Craig Model L630 Service Bulletin# 080178

SB: #080178
August 1, 1978

SUBJECT: L630, C.B. Transceiver

AUDIO P.C.B. (Top View)

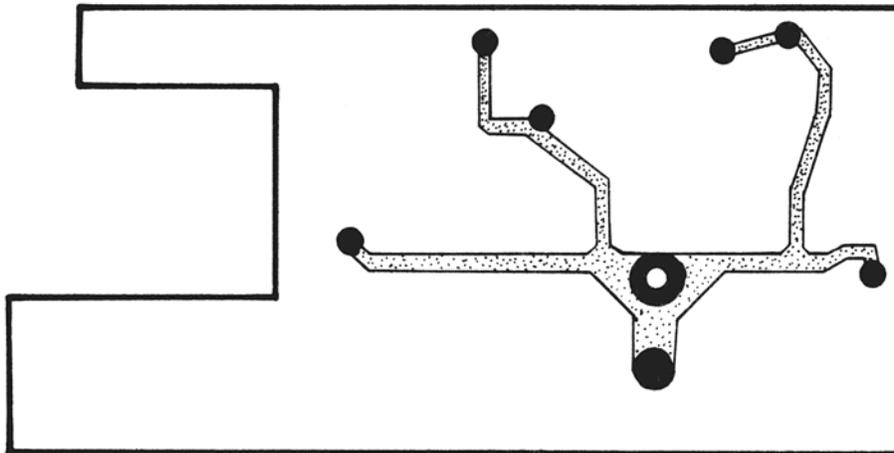
MAY EXHIBIT PROBLEMS: One or more of the following: low volume, oscillation, no audio dim channel display, or may transmit one frequency on all channel positions.

CAUSE: Problem is due to poor grounding of Audio P.C.B.

SOLUTION: Resolder ground connections on the audio P.C.B. Traces should be soldered on the component side of the P.C.B. as indicated below.
